# RENOVATION OF GALEHOUSE (A BUILDING), MCLEOD (S BUILDING), AND NATURAL SCIENCES (N BUILDING)

Cape Fear Community College Wilmington, North Carolina SCO #17-18154-01A; NCCCS #2352 BMG Project No. 2018023.00

#### **ADDENDUM NO. 1**

E106

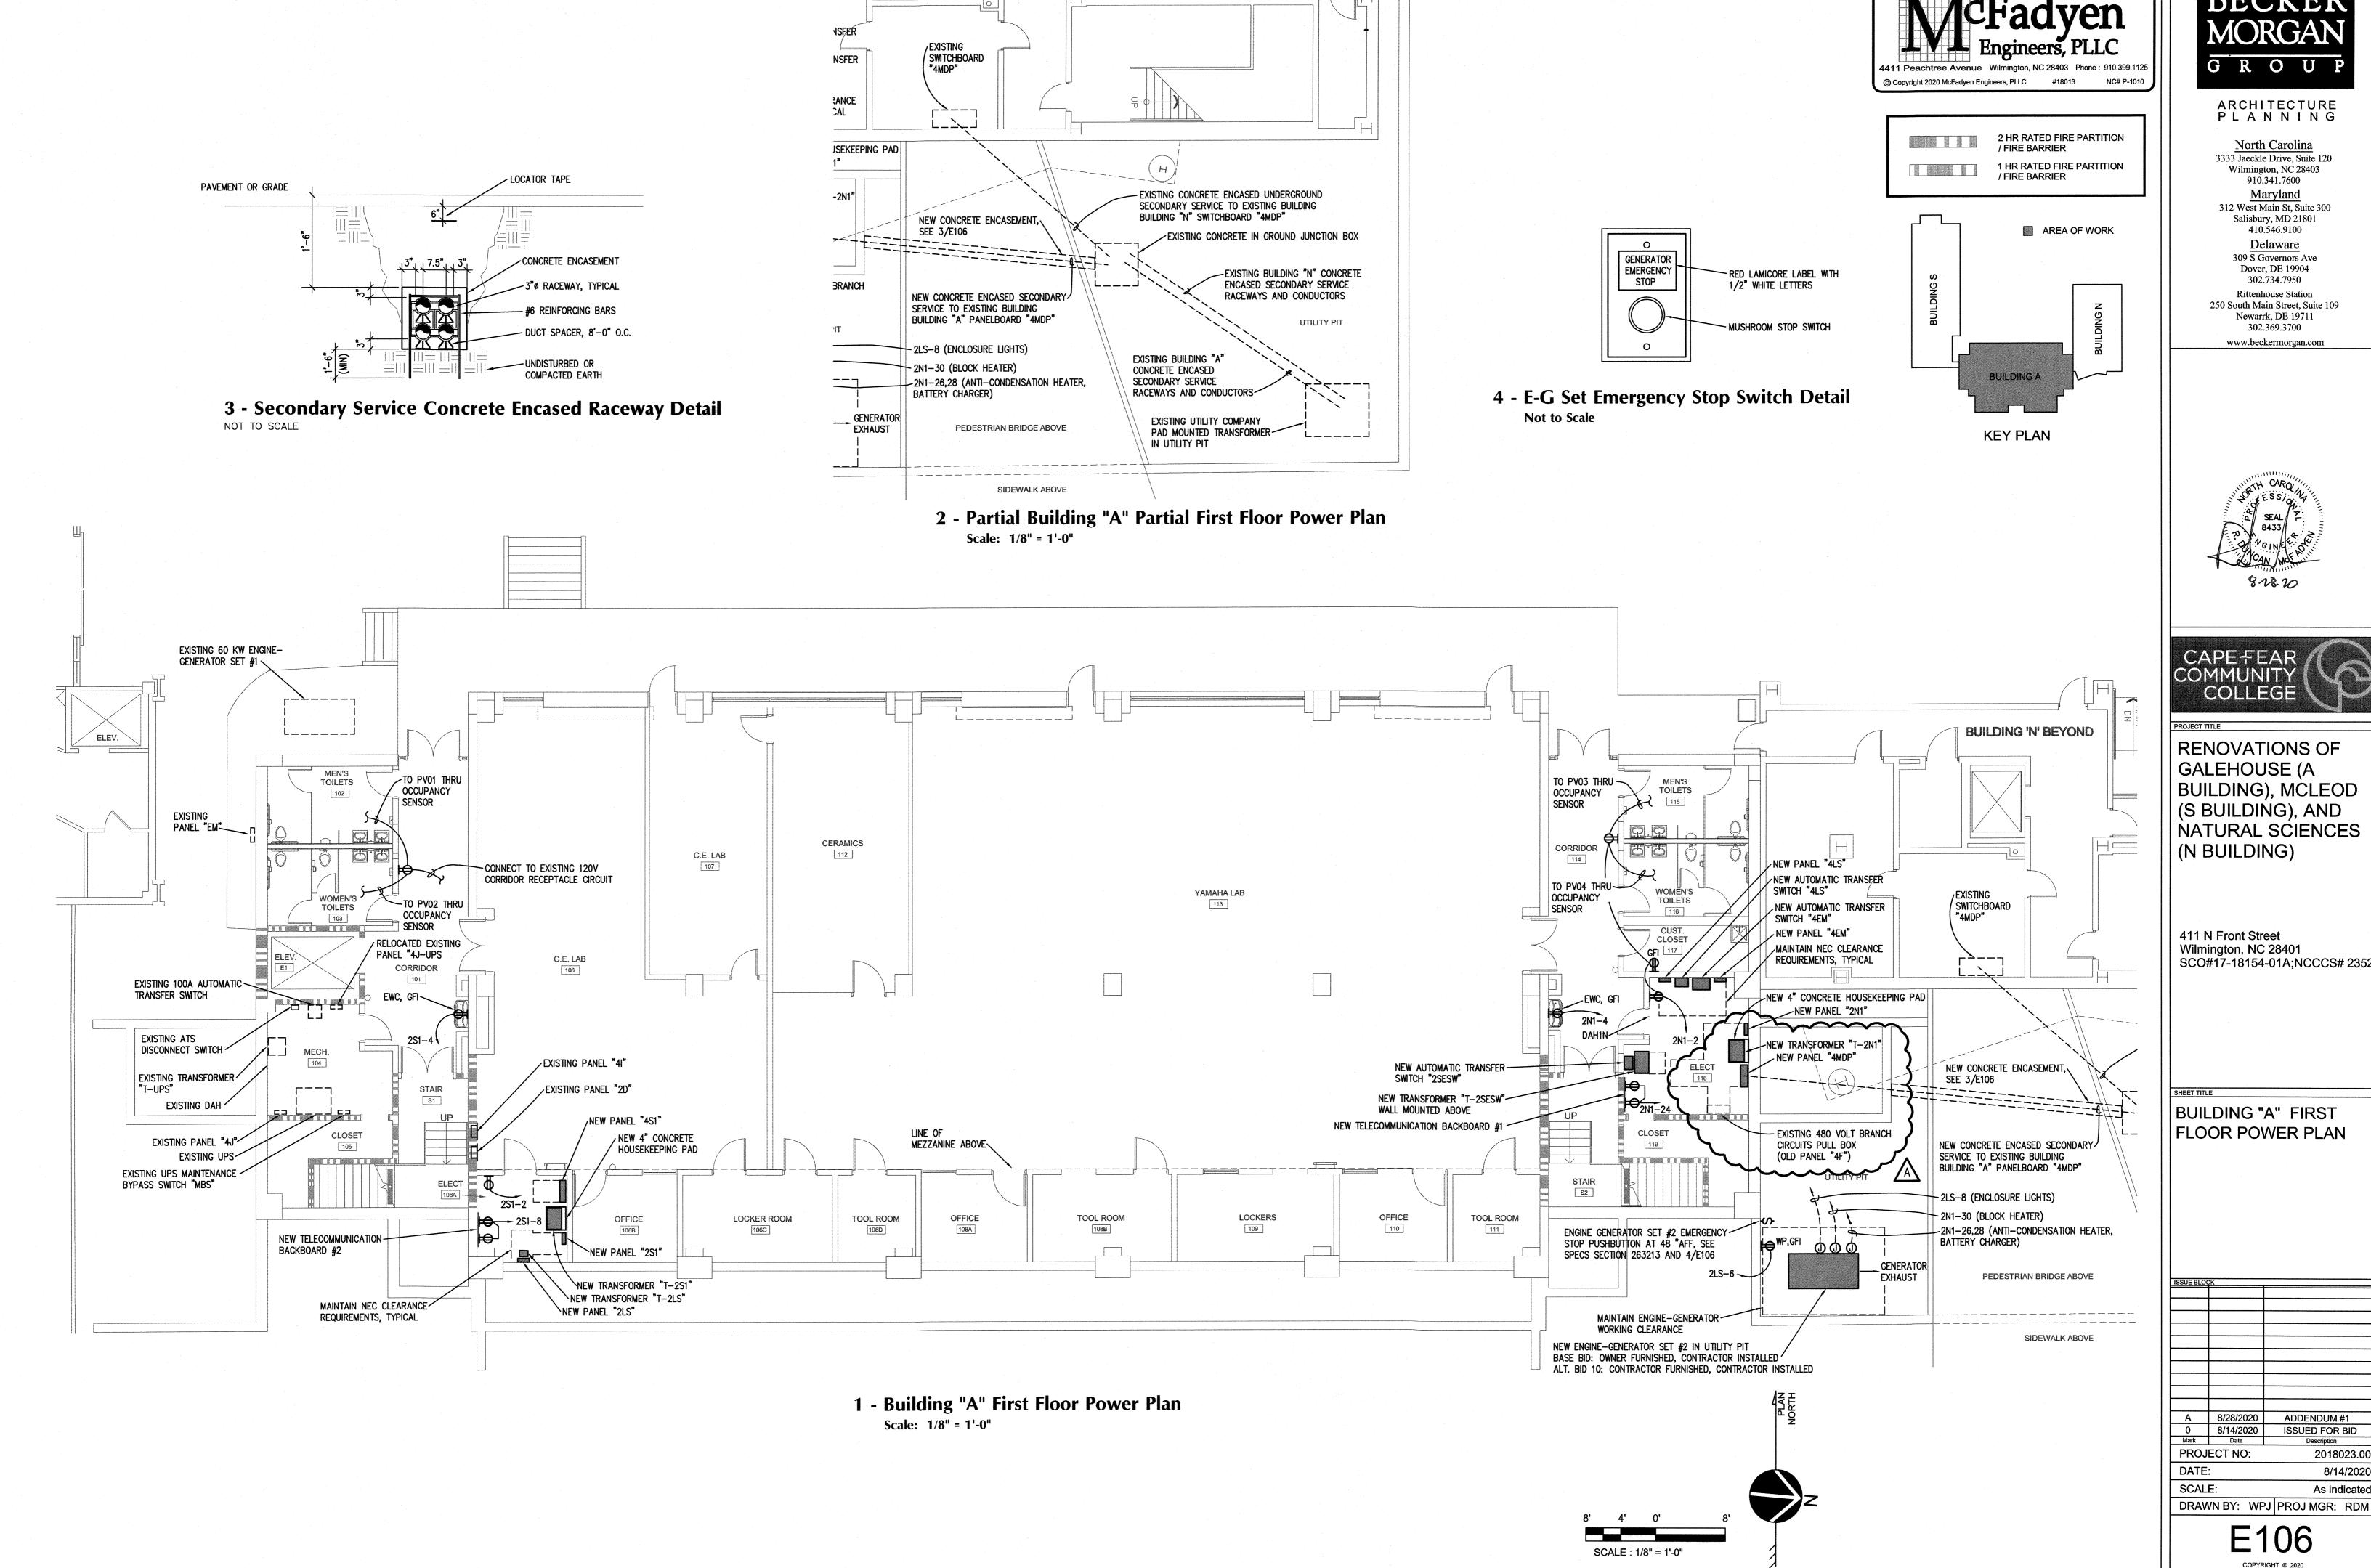
- p. E009.2 ELECTRICAL PANEL SCHEDULES: REVISED. Added EUH2 to Panel "2NR" schedule.
- q. E106 BUILDING "A" FIRST FLOOR POWER PLAN: REVISED new secondary service termination location in new Panel "4MDP".

ALTERNATE 1 BUILDING "A" FIRST FLOOR POWER PLAN

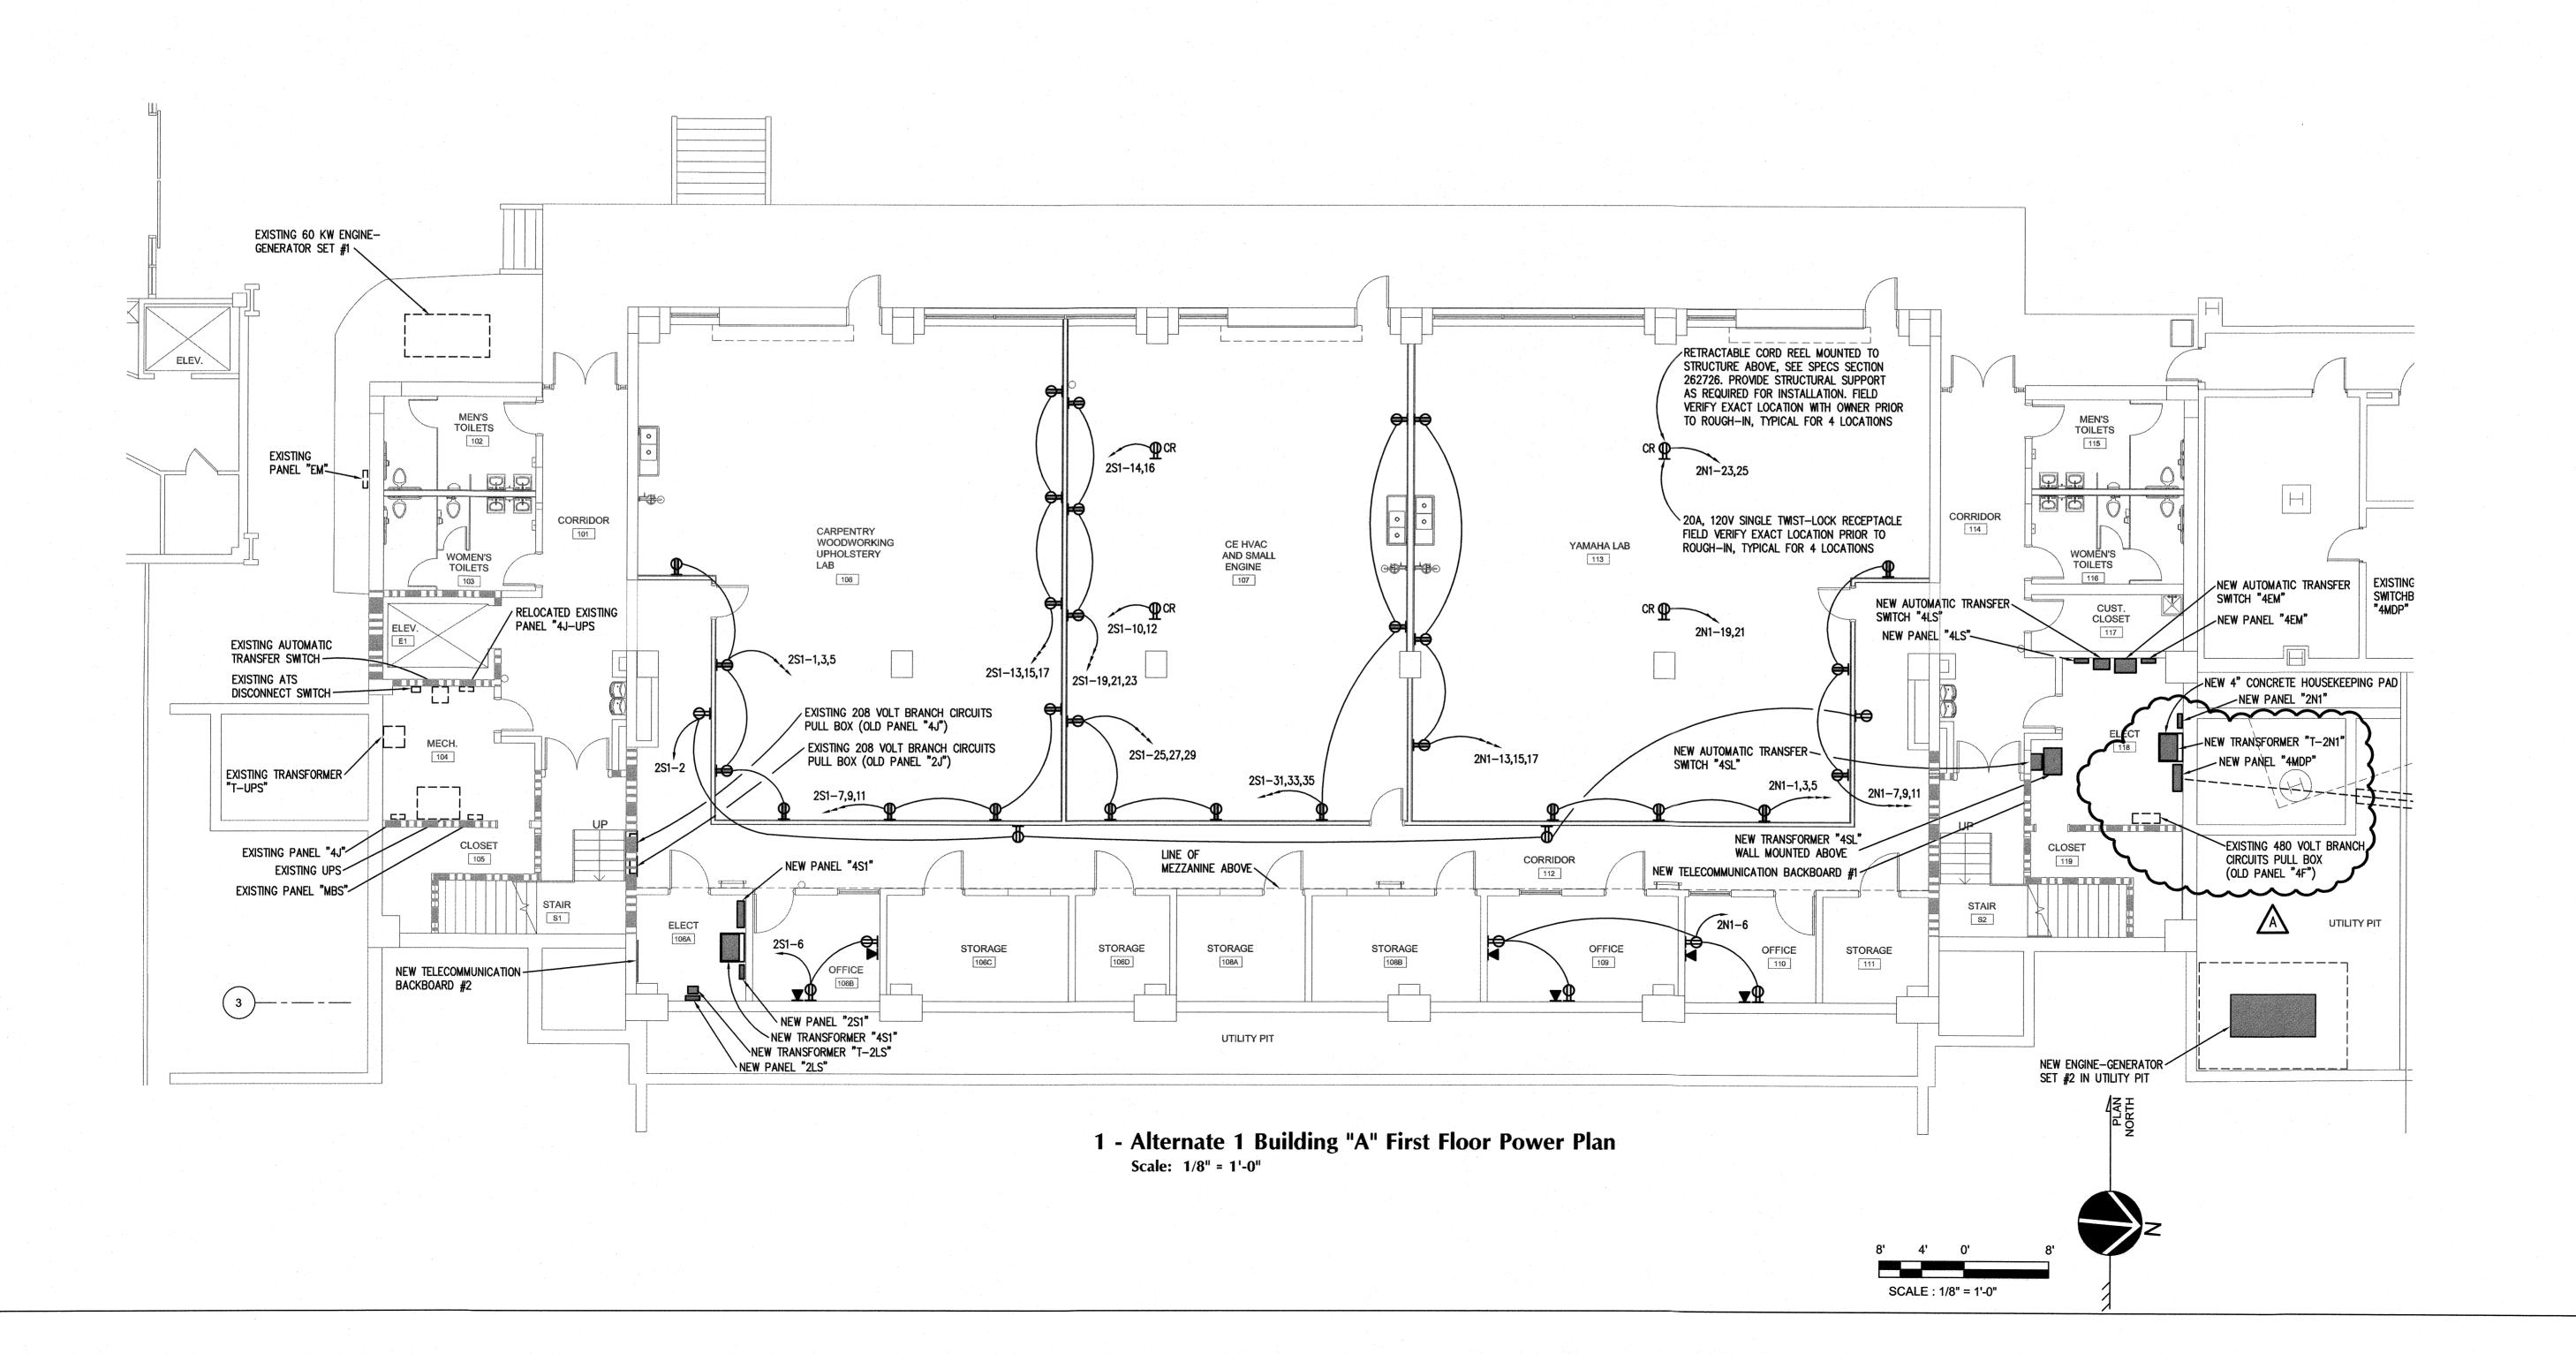
- r. E106A ALTERNATE 1 BUILDING "A" FIRST FLOOR POWER PLAN: REVISED new secondary service termination location in new Panel "4MDP".
- s. E110 BUILDING "A" ROOF POWER, LIGHTING AND SYSTEMS PLAN: REVISED. Added EUH2 location and branch circuit. Added existing ductless split unit location and branch circuit.
